Recall Service Bulletin RSB21-500-001

APPLIES TO: This Recall service bulletin applies to 2019 through 2021 model year, S-180 model emergency response pumpers built between April 2019 and November 2020.

CONDITION: Incorrect terminal installed on harness connected to pump control solenoid.

CORRECTION: Replace with correct terminals.

Figure 2.1

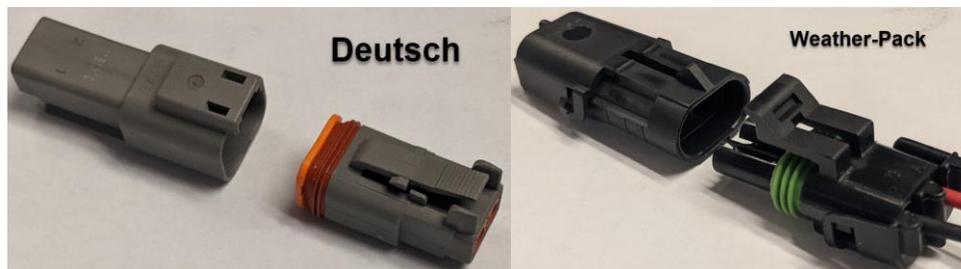
1. Locate 2 connectors that connect the harness to the pump shift control solenoid. These are typically located towards the middle of the truck on the drivers side frame rail. Road Solenoid connector will have orange wire labeled ERV738 & black wire labeled ERV510D. Pump solenoid connector will have blue wire labeled ERV739 & black wire labeled ERV510E.
2. Identify type of connector. Deutsch or Weather-Pack. *See Figure 2.1*

Figure 3.1

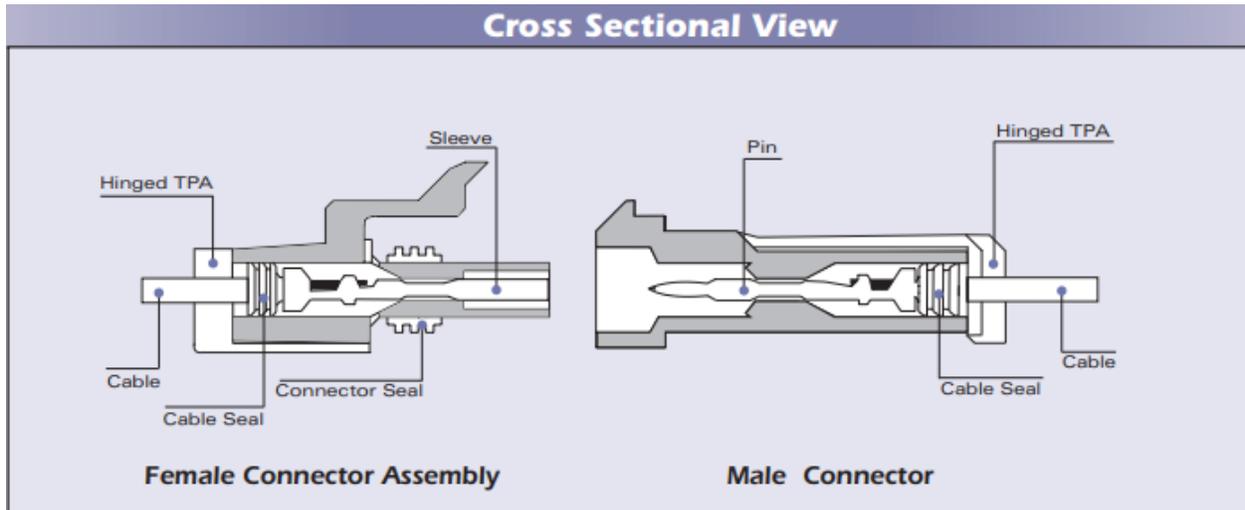
3. If connection is made with Deutsch connector no further action is needed. If connection is made with Weather-Pack connector move on to step 4.
4. Disconnect both Weather-Pack connectors that connect the harness to the pump shift control solenoid.
5. Inspect the harness side connector (Female connector assembly) terminals to verify they are a female (sleeve) terminal, not a male (pin) terminal. *See figure 3.1*

6. If female (sleeve) terminals are installed the connection is correct & the connectors can be reconnected as they were.
7. If male (pin) terminals were installed in the female connector assembly they will need to be replaced with the correct female (sleeve) terminals.
8. Open hinged TPA on female connector assembly. (See cross sectional view in *figure 3.1* above for hinged TPA location)
9. Insert terminal removal tool into front of female connector assembly & remove incorrect male (pin) terminal. *See Figure 4.1*
